TOYOTA

EG-00037T-TME

Technical Service Bulletin

1NR Engine: Hard to start

Example of how deposits could cause lack of compression.

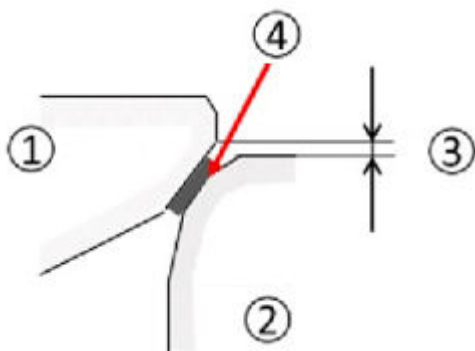
Carbon deposits are not abnormal inside combustion chamber, but some of the existing fuel additives in the market can affect deposits concentration in terms of amount and size. Once those deposits flow through the exhaust valves, the biggest ones could remain between the valve and the valve seat creating a gap. This gap causes lack of compression and consequently, difficulties to start the engine.

This bulletin informs about applicable parts that must be changed to start the engine within the standard cranking time.
